RECEIPT DATE: 07/26/2021 **ONSITE SEWAGE DISPOSAL SYSTEM** P 569624

PROPERTY ADDRESS: 1604 Florence Road, Mount Airy, MD 21771

SEPTIC SYSTEM
INSTALLATION SITE PLAN
PATRICK FAMILY LIMITED
PARTNERSHIP
LOT 2
ZONED: RC-DEO
TAX MAP NO.: 6 GRID NO.: 17 PARCEL NO.: 65
4TH ELECTION DISTRICT HOWARD COUNTY, MARYLAND
SCALE: 1" = 40' DATE: OCTOBER 23, 2020
SHEET 1 OF 1

NOT TO SCALE (2:1:40)

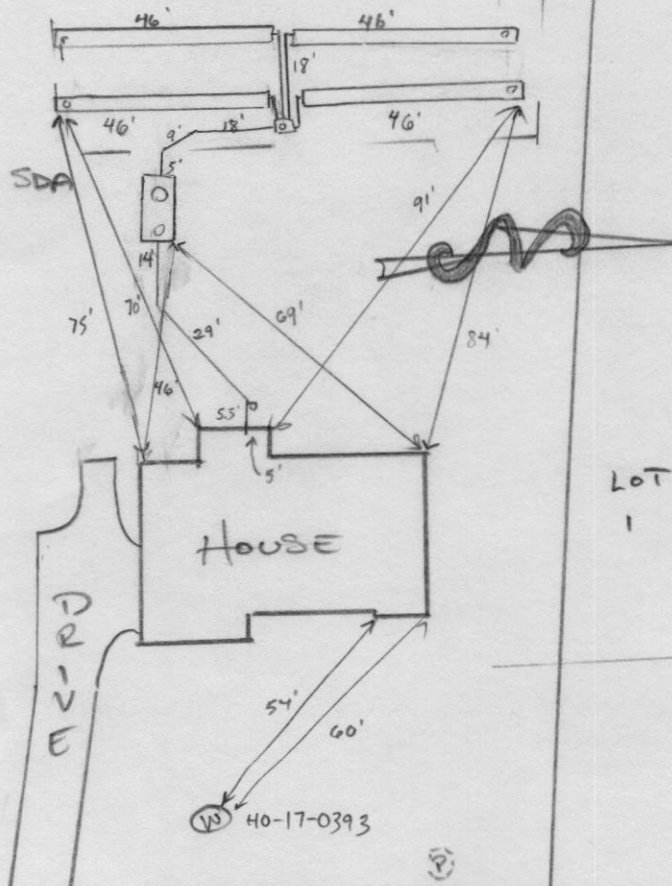
PRE-CONSTRUCTION:
08/02/2021 CONFIRMED CONTOUR. SHC RAISED BY ~2' IN HOUSE. OK. (S)

INSTALLATION: 8/12/21 SHC, SI constructed. Tank set and d-box set and leveled. 4x46' trenches installed. (S)
